Service Bulletin

SEB01-2

MAIN LANDING GEAR ACTUATOR INSPECTION

FIGURE 1. MAIN LANDING GEAR ACTUATOR INSPECTION

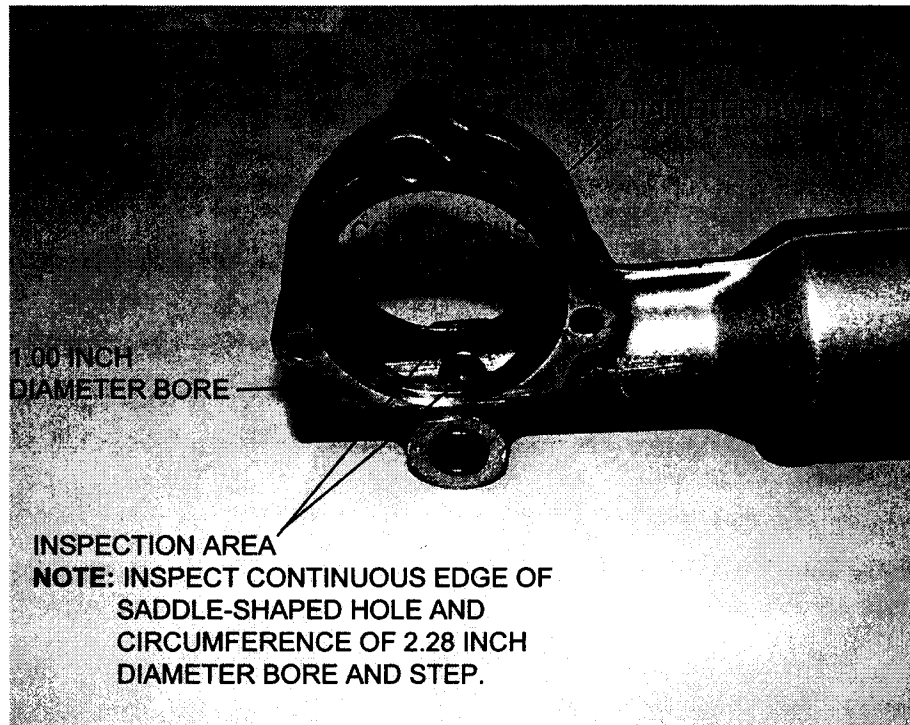
- C. (Refer to Figure 1.) Perform a fluorescent penetrant inspection in location indicated by Figure 1 on both sides of each main landing gear actuator body.

- (5) Examine the areas under black light. An 8X to 10X magnifying glass should be used in the examination as some cracks are difficult to see with the naked eye.

- D. If a crack or cracks are detected, the actuator or actuator body must be replaced.
- E. If no cracks are detected on part number 1281000-1, 1281000-2, 9882000-1, 9882000-2, 9882015-1 or 9882015-2 Actuator Assemblies and 1281001-1, 1281001-2 or 1281001-3 Actuator Bodies, proceed to Step 2.

2. Polish edge of hole intersection of main landing gear actuator.
 - A. (Refer to Figure 1.) Using fine grit emery cloth (600 grit), or equivalent, polish edge of hole intersection as shown in Figure 1.
 - (1) Smooth continuous edge of saddle-shaped oval hole where 1.00 inch diameter bore transitions 2.28 inch diameter bore, so that no sharp edges or tool marks can be felt by finger tip.
 - (2) Smooth circumference of 2.28 inch diameter bore and step so that no sharp edges or tool marks can be felt by finger tip.
 - (3) Flush actuator body with solvent to remove any metal shavings, fluorescent penetrant solution or other foreign matter.
3. (Refer to applicable Service Manual.) Assemble and install Main Landing Gear Actuator.
